# CITY OF ALBUQUERQUE

RE: **Covered Wagon**  
**13609 Covered wagon Ave.**  
**Grading and Drainage Plan**  
**Engineers Stamp Date 8/29/16 (L23D014)**

Based upon the information provided in your submittal received 8/31/16, this plan is approved for Grading Permit and Building Permit.

ENGINEER'S SEAL	COVERED WAGON SUBDIVISION-LOT 15	DRAWN BY WCUJ
	GRADING AND DRAINAGE PLAN	DATE 7-29-16
		21511-LAYOUT-4-02-15
DAVID SOULE P.E. #14522		SHEET #
		JOB # 21510

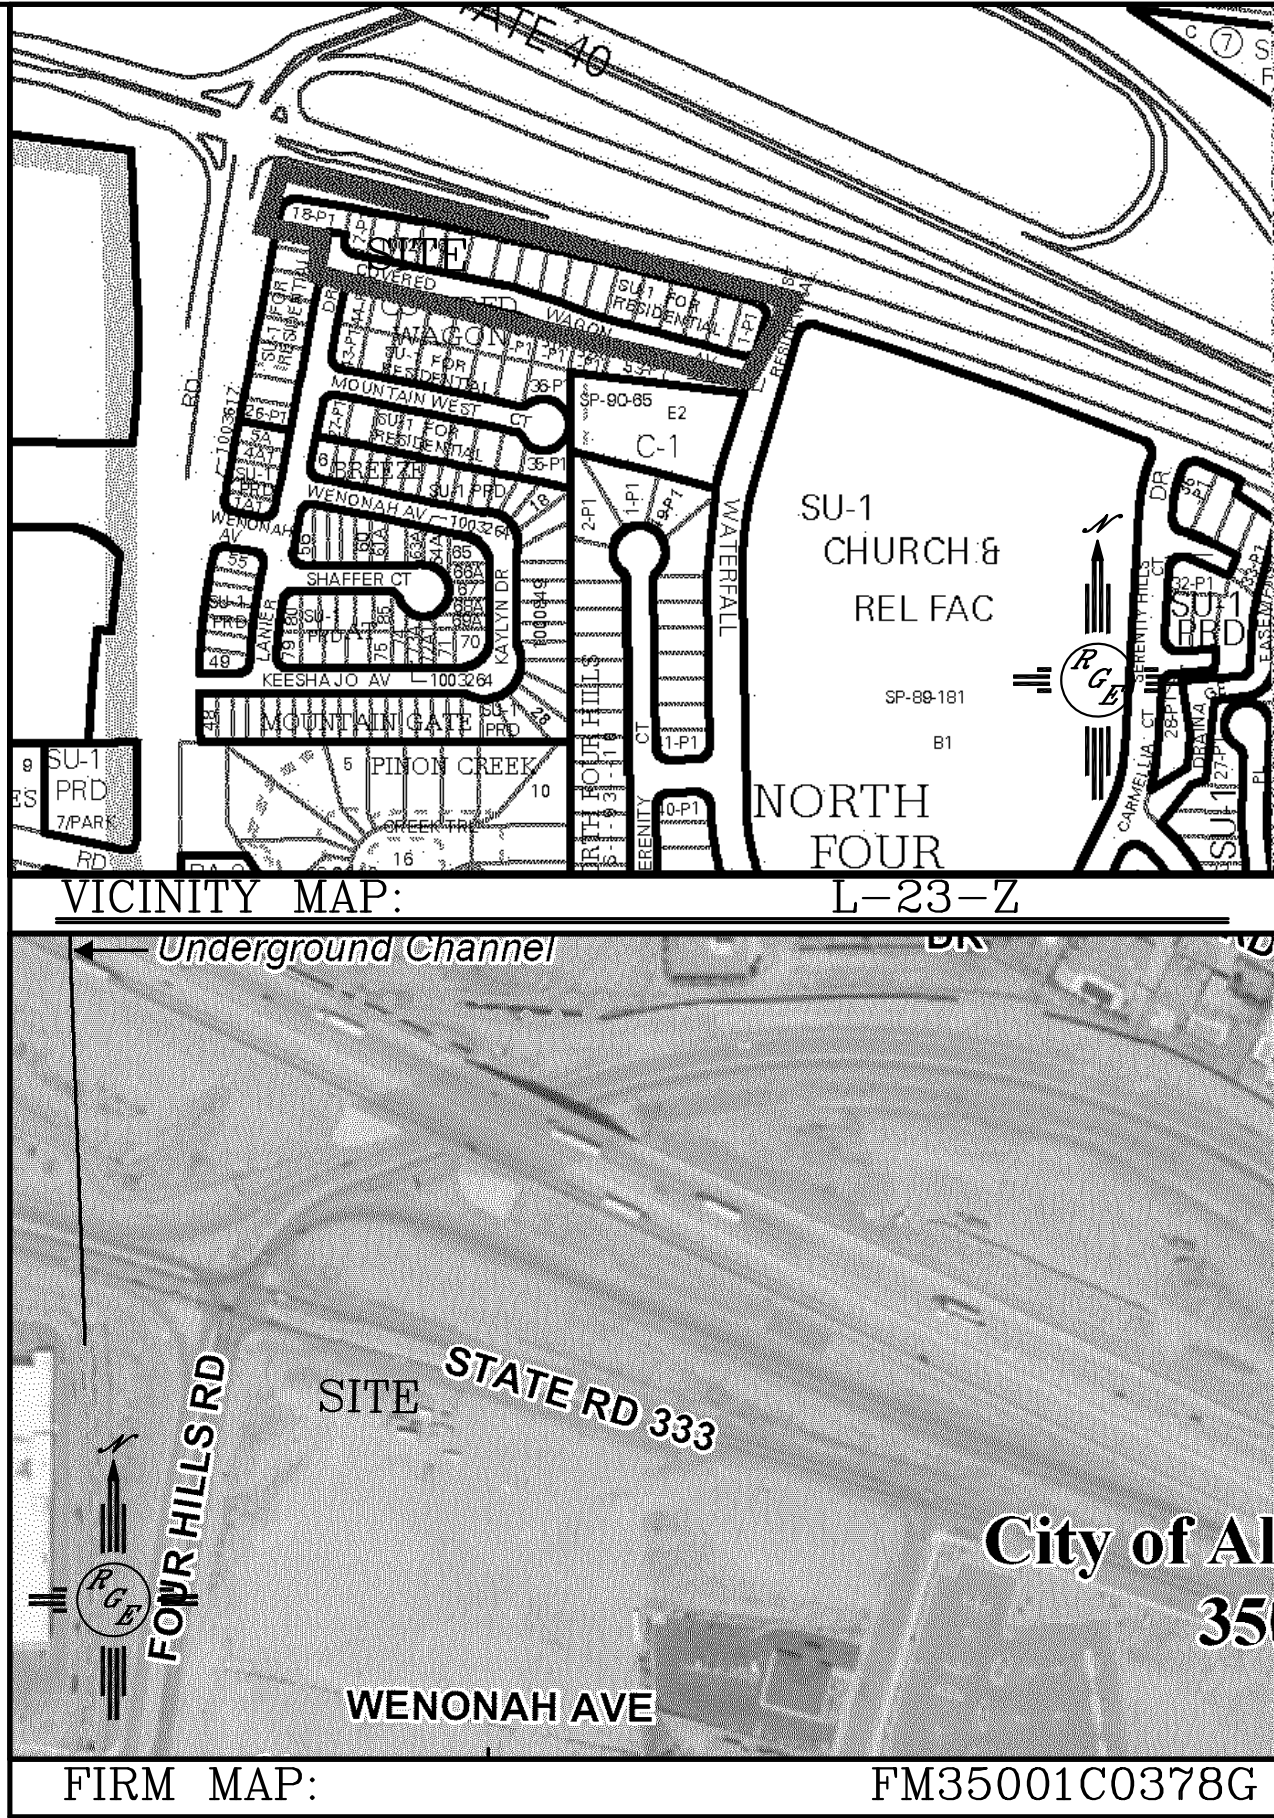
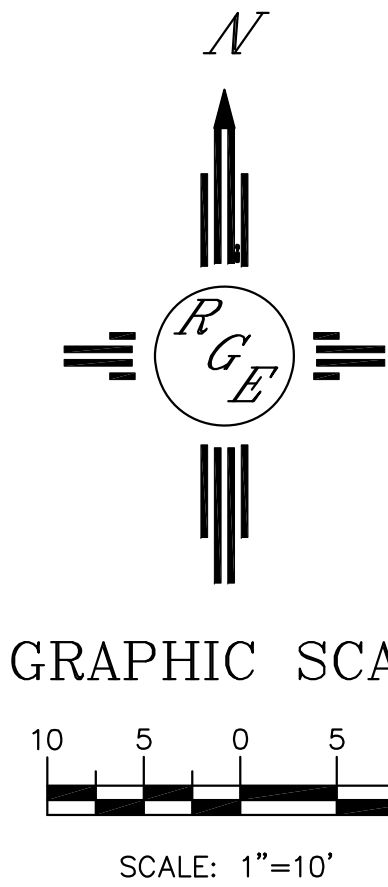
- An approved ESC plan is required for all the lots, plus an ESC Permit is required for each lot which have different owners.  
An ESC has been approved
- Address the First Flush requirements. All flows must exit the front yard via a landscaped pond.  
The first flush volume has been shown and pond added to the plan
- Provide how erosion will be prevented from entering the adjacent property.  
Note number 4 has been added to the plan to address the conformance to the ESC
- Provide an excerpt about the retaining wall in the rear yards. Who will be responsible for the maintenance of the retaining wall?  
As discussed on the phone, the wall was constructed under work order
- Was the retaining wall in the rear yards approved and certified?  
The wall was approved and certified under previous work order.
